Access Compliance Report

Public Rights-of-Way

(Curb Ramps)

Intersection ID: N/A	Main Street: ARBOR_LOOP_DR	Cross Street: ANSLEY_GARDEN_DR	Location: W
ADA ID: 7F0F328E7E79	Ramp Type: Perp	Initial Pass/Fail: Pass	Overall Compliance: No
Severity Score: 0.25			
Codes/Mitigation Info/Possible Solution		Field Measurements/Component Compliance

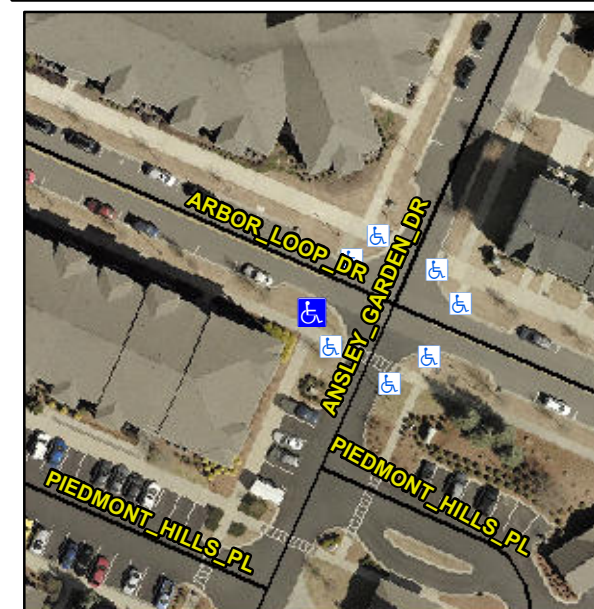
R304.5.3, R304.2.2-Perp, R304.3.2-Para

Compliance	Description	Data	Compliance	Description	Data
N/A	Ramp Length (in)	81.5	Yes	Ramp Slope (%)	5.7
Yes	Ramp Width (in)	71.0	No	Ramp XSlope (%)	2.3
Yes	Flare Type L	Curbed_NoWalkSurface	Yes	Flare Type RT	N/A
Yes	Flare Slope LT (%)	N/A	N/A	Flare Slope RT (%)	N/A
N/A	Flare Traversable LT?	No	N/A	Flare Traversable RT?	No
Yes	Landing Length (in)	68.0	Yes	DWS Provided?	Yes
Yes	Landing Width (in)	84.0	Yes	DWS Contrast?	Yes
No	Landing Slope (%)	2.2	Yes	DWS Length (in)	24.0
Yes	Landing X Slope (%)	1.4	Yes	DWS Full Width?	Yes
N/A	Landing Curb? (Y/N)	No	Yes	DWS Offset (in)	0.0
N/A	Shared Landing?	No			
Yes	Gutter Ponding?	No	Yes	Gutter Slope (%)	0.2
Yes	Gutter Lip Ht (in)	0.0	Yes	Gutter X Slope (%)	0.0
N/A	Painted X Walk1?	No	N/A	Painted X Walk2?	N/A
	X Walk 1 Direction	To NE		X Walk 2 Direction	N/A
N/A	X Walk 1 Width (in)	N/A	N/A	X Walk 2 Width (in)	N/A
	X Walk 1 Slope (%)	1.8		X Walk 2 Slope (%)	N/A
	X Walk 1 X Slope (%)	0.3		X Walk 2 X Slope (%)	N/A

Remove & Replace Entire Ramp.
